# UNITED STATES PATENT AND TRADEMARK OFFICE

APPLICATION NO.	FILING DATE	FIRST NAMED INVENTOR	ATTORNEY DOCKET NO.	CONFIRMATION NO.
10/675,088	09/30/2003	Jung-Seon Park	CU-3336 VE	4762
26530 7590 09/06/2007 LADAS & PARRY LLP 224 SOUTH MICHIGAN AVENUE SUITE 1600 CHICAGO, IL 60604			EXAMINER KARLS, SHAY LYNN	
			ART UNIT 1744	PAPER NUMBER
			MAIL DATE 09/06/2007	DELIVERY MODE PAPER

<b>Office Action Summary</b>	<b>Application No.</b> 10/675,088	<b>Applicant(s)</b> PARK ET AL.	
	<b>Examiner</b> Shay L. Karls	<b>Art Unit</b> 1744

**DETAILED ACTION*****Drawings***

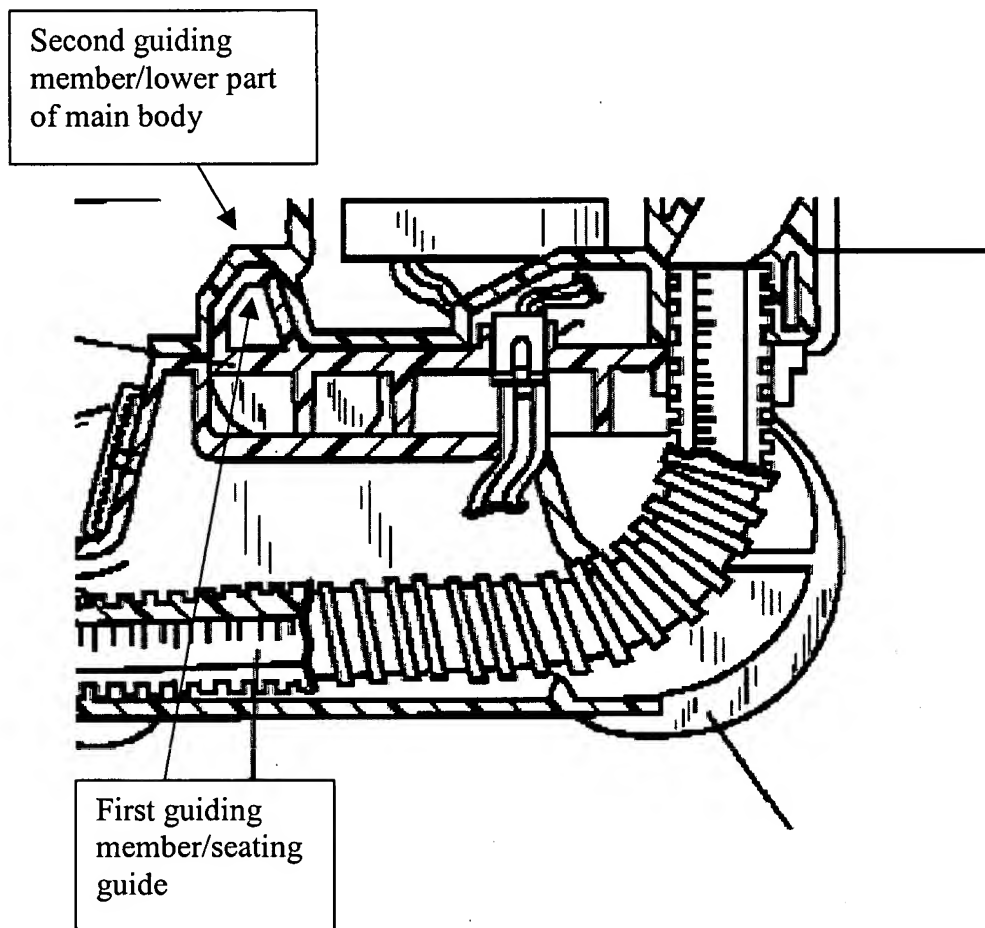
connecting portion (200) that protrudes upwardly from the connecting portion (claim 1). There is a second guiding member corresponding to the first guiding member on the lower part of the main body (see figure below) (claim 13). The at least one guiding member is shaped in to a convex protrusion (cross section shows a convex shape in figure below) and the second guiding member is shaped in to a concave groove (cross section shows a concave groove in figure below) (claim 13). The main body has a corresponding receptacle into which the second guiding member is received (portion 44 of figure 7 receives the concave second guiding member).

Fig. 1

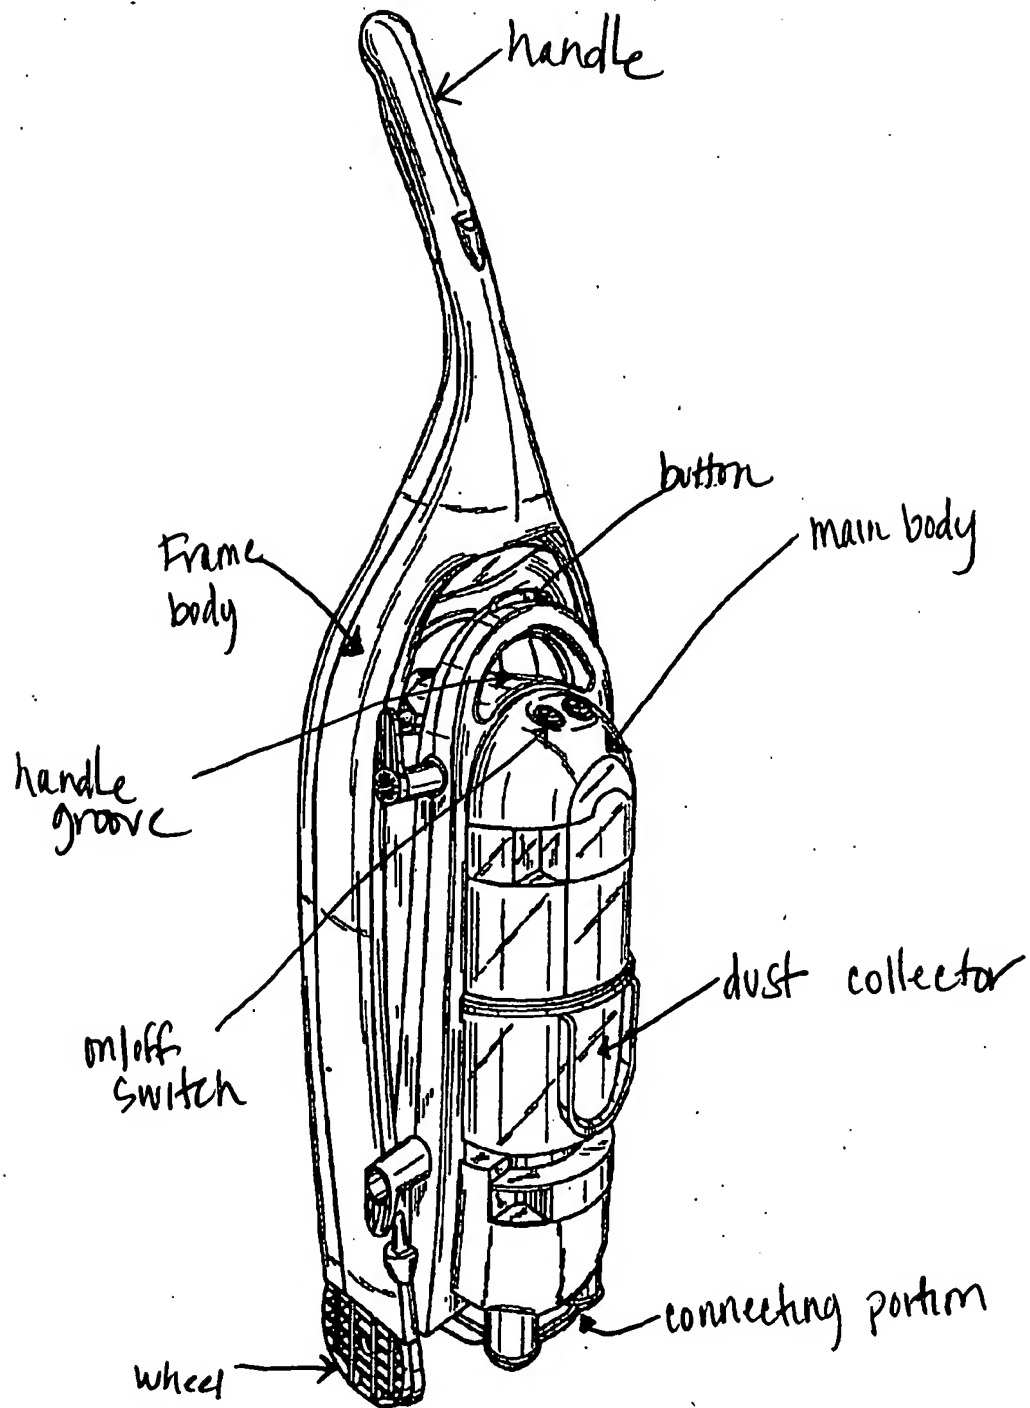
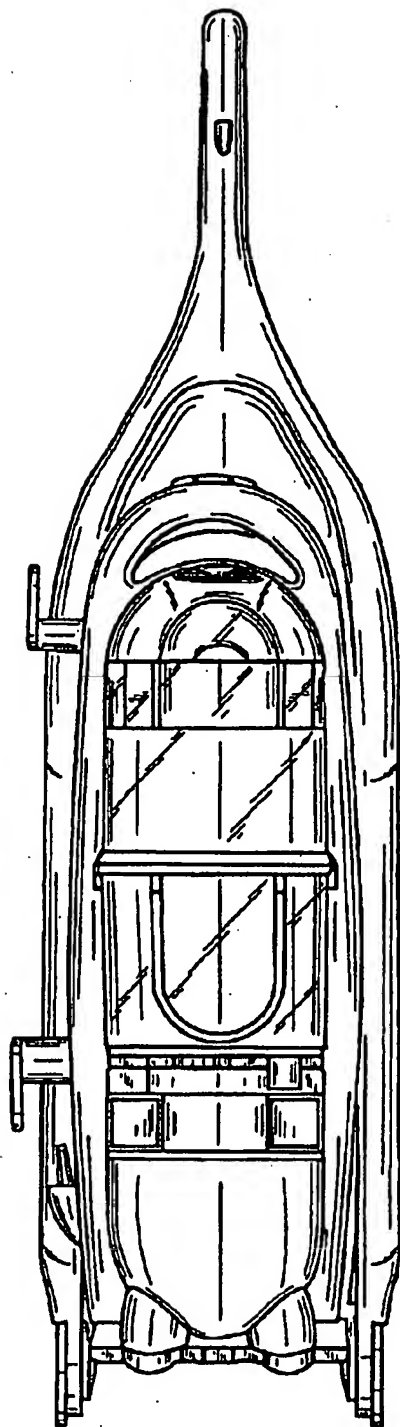
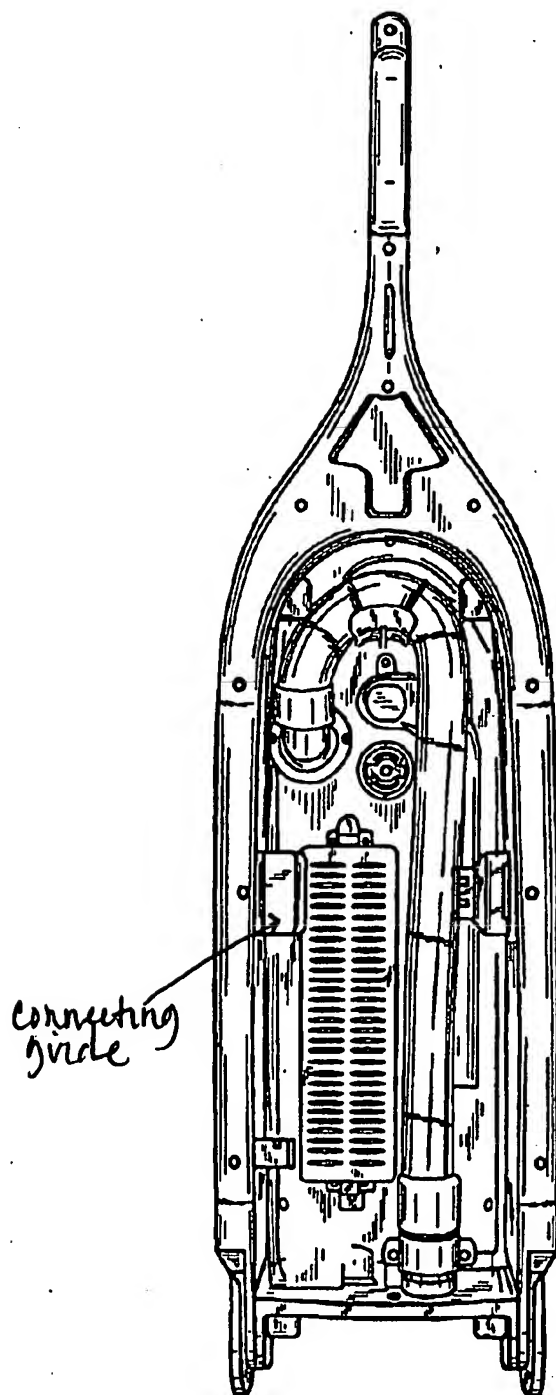
Downey teaches a vacuum cleaning handle portion for drawing in air having dust and dirt. See attached figures for labeled elements. There is a main body including a body frame, a dust collector connected to the body frame and a drive motor (figure 1). There is a frame assembly including a frame body (figure 1) and a connecting portion (figure 1, 5 and 7) formed with a lower part of the frame body. The frame body further comprises a front casing facing forward with respect to the vacuum cleaner and a rear casing coupled to the front casing (figure 5). The frame body is shaped to correspond to an outer circumference of the main body (figure 1).

With regards to claim 5, the frame body further comprises a wheel (figure 1) connected to the lower part of the frame assembly.

With regards to claim 6, the main body of the vacuum is connected to the dust collector (figure 1) and further comprises a dust receptacle (inside of dust collector) removably connected to the body frame for collecting dust and dirt. There is a button formed at an upper part of the body frame (figure 1).

With regards to claim 7, the frame assembly further comprises a frame handle (figure 1) disposed at an upper part thereof, and there is a handle groove (figure 1) disposed at a position corresponding to the button of the main body of the vacuum cleaner.

With regards to claim 19, there is an on/off switch (figure 1) disposed at a front part of the main body.

**Fig. 3**

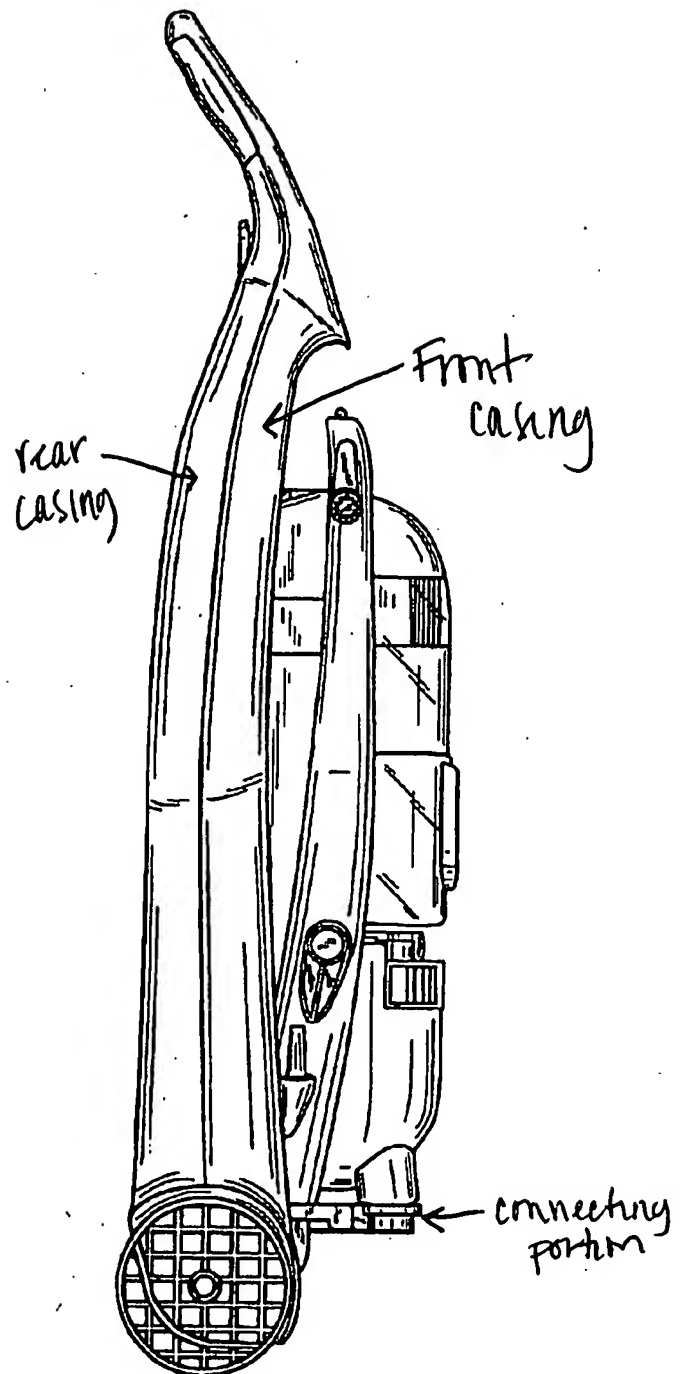
With regards to claim 4, the frame assembly further comprises a connecting guide for removable connecting accessories to the vacuum cleaner (figure 3).

**Fig. 7**

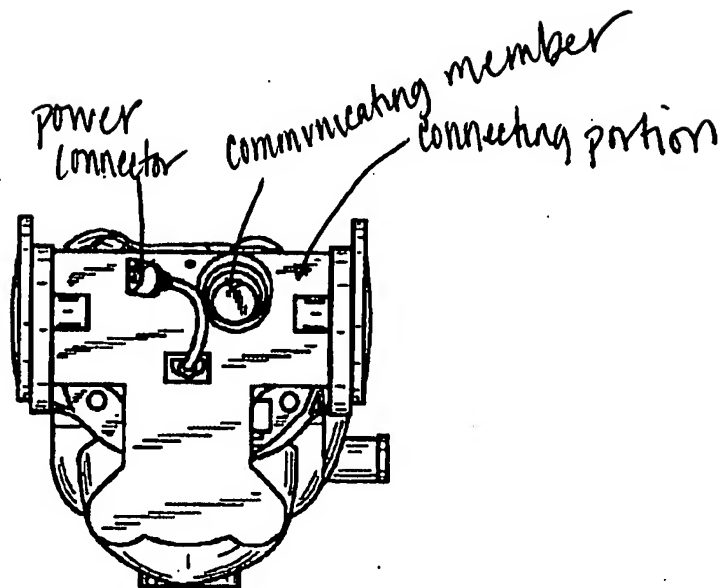
With regards to claim 10, the connecting portion comprises a communicating member (figure 7) formed at the main body of the vacuum.

With regards to claim 11, there is a power connector disposed on the lower part of the main body (figure 7).
